# Parts & Accessories Bulletin

P&A #336

## 1987-1/2 HAYES REAR BRAKE MASTER CYLINDER INTERFERENCE WITH P&A HIGH PERFORMANCE EXHAUST SYSTEMS BY KERKER

Figure 1, Brackets

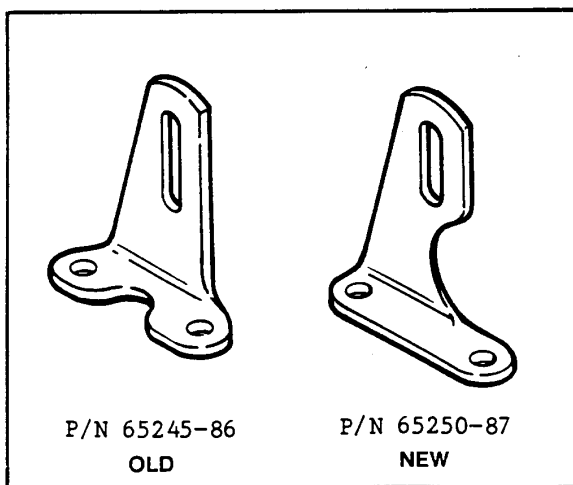
See Figure 1. A new Exhaust System Bracket, P/N 65250-87, **MUST** be used on 1987-1/2 and later FXR's equipped with the Hayes Rear Brake Master Cylinder when installing FXR Hi-Performance Exhaust Systems by Kerker (P/N 65212-86).

<u>YEAR</u>	<u>REQUIRED BRACKET(S)</u>
1) 1984 to 1986	No additional components required.
2) Early 1987 w/out Hayes Rear Brake Master Cylinder	Additional Rear Bracket Kit P/N 65228-87 is required.
3) 1987-1/2 to Present w/new Hayes Rear Brake Master Cylinder	Additional Rear Bracket Kit P/N 65228-87 <u>and</u> new transmission bracket P/N 65250-87 are required.

Figure 2, Master Cylinder

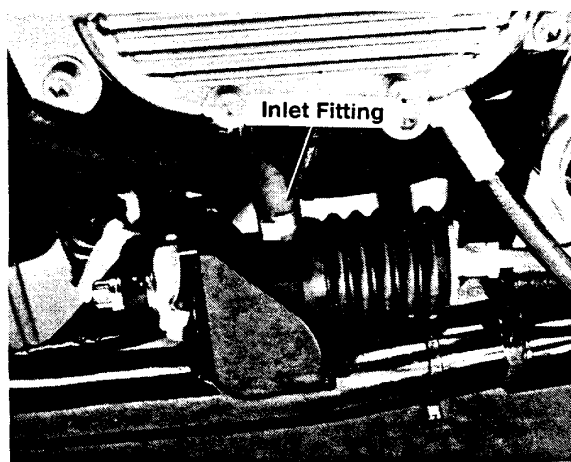
See Figure 2. The bracket (P/N 65245-86) currently supplied with the FXR Hi-Performance Exhaust System by Kerker allows inadequate clearance and may break off the plastic inlet fitting on the new 1987-1/2 Hayes Rear Brake Master Cylinders.
